Access Compliance Report

Public Rights-of-Way

(Curb Ramps)

Intersection ID: 14091	Main Street: E_7TH_ST	Cross Street: N_CASWELL_RD	Location: SW
ADA ID: 32ECC32E6598	Ramp Type: Perp	Initial Pass/Fail: Fail	Overall Compliance: No
Severity Score: 13.75			
Codes/Mitigation Info/Possible Solution		Field Measurements/Component Compliance

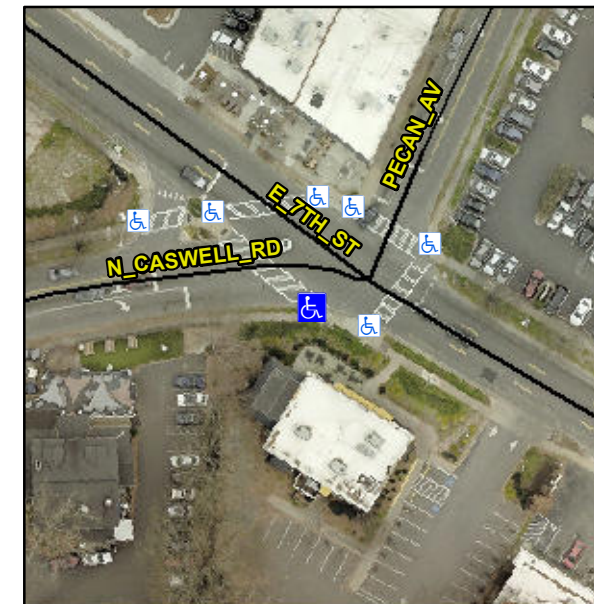
Not Found, R304.2.2

Compliance	Description	Data	Compliance	Description	Data
N/A	Ramp Length (in)	72.0	No	Ramp Slope (%)	10.6
Yes	Ramp Width (in)	48.0	Yes	Ramp XSlope (%)	3.4
N/A	Flare Type LT	N/A	N/A	Flare Type RT	N/A
N/A	Flare Slope LT (%)	N/A	N/A	Flare Slope RT (%)	N/A
N/A	Flare Traversable LT?	N/A	N/A	Flare Traversable RT?	N/A
N/A	Landing Length (in)	N/A	N/A	DWS Provided?	N/A
N/A	Landing Width (in)	N/A	N/A	DWS Contrast?	N/A
N/A	Landing Slope (%)	N/A	N/A	DWS Length (in)	N/A
N/A	Landing X Slope (%)	N/A	N/A	DWS Full Width?	N/A
N/A	Landing Curb? (Y/N)	N/A	N/A	DWS Offset (in)	N/A
N/A	Shared Landing?	N/A			
N/A	Gutter Ponding?	N/A	N/A	Gutter Slope (%)	N/A
N/A	Gutter Lip Ht (in)	N/A	N/A	Gutter X Slope (%)	N/A
N/A	Painted X Walk1?	Yes	N/A	Painted X Walk2?	N/A
	X Walk 1 Direction	To NW		X Walk 2 Direction	N/A
N/A	X Walk 1 Width (in)	128.0	N/A	X Walk 2 Width (in)	N/A
	X Walk 1 Slope (%)	4.8		X Walk 2 Slope (%)	N/A
	X Walk 1 X Slope (%)	5.7		X Walk 2 X Slope (%)	N/A

Remove & Replace Entire Ramp.
